MEMORANDUM

SUBJECT: Item 3.8, DA2023/0123 - 9 Lincoln Avenue, Collaroy

(Figure 1: Western envelope encroachment from amended plans dated 14 September 2023).

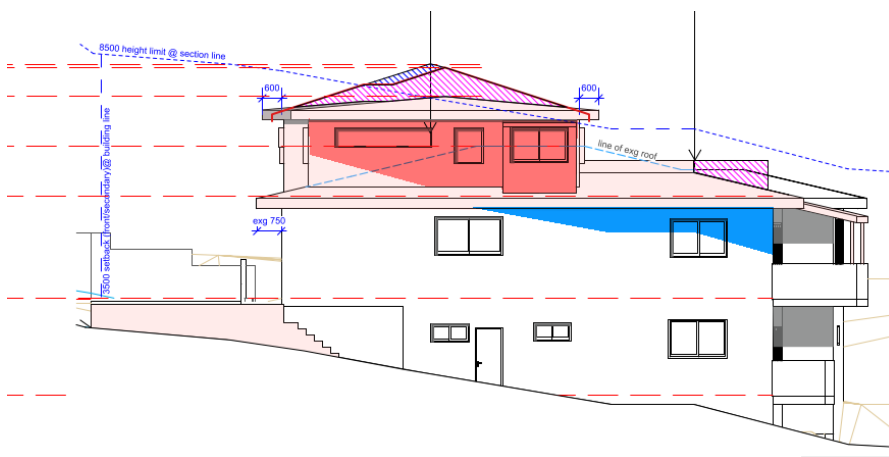
Whilst it is acknowledged that the western side setback when measured from the upper floor addition has been increased, the extent of side boundary envelope encroachment is still considered to be significant. In addition, the floor space area to the upper floor has been increased, rather than reduced. This concern with the proposed development has been apparent since the issue of the Request for Further Information Letter dated 28 April 2023. The encroachment still extends the entire length of the upper floor along the western elevation which will amalgamate with the non-compliant building envelope of the existing dwelling, further exacerbating the extent of non-compliance.

It is concluded that the proposed building envelope is still inconsistent with the aims and objectives of the control. The figures below depict a comparison between the amended plans received on 14 September 2023 and the amended plans received on 27 September 2023, demonstrating the minimal reduction to the side boundary envelope encroachment to the western elevation.
